Auko-Tex Limited (Extended building)

South Panishail zerani bazar, BKSP, Gazipur, Dhaka

14 January 2024

2. Observation

Test report

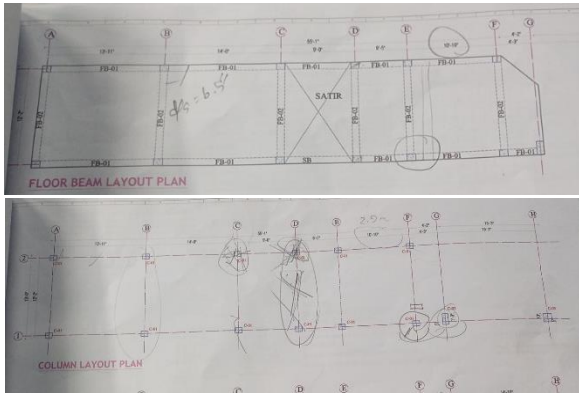
Description: In the provided design report concrete compression strength considered 4000 psi for column. But cylinder test report was available from ground floor column only, which does not meet the frequency of testing of BNBC. Thus, ground columns are observed marginally overstressed from cursory calculation considering minimum concrete strength. The building engineer is required to revise the concrete strength in the design report by performing core test.

Steel stair, floor Beam and Sub-station Room

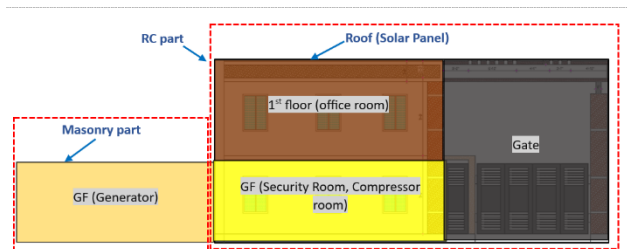
Description: Column and beam layouts were not fully matched with as built drawings. Also, the column of sub-station room was found brick masonry instead of RCC. Moreover, no as built drawings were available for steel stair.
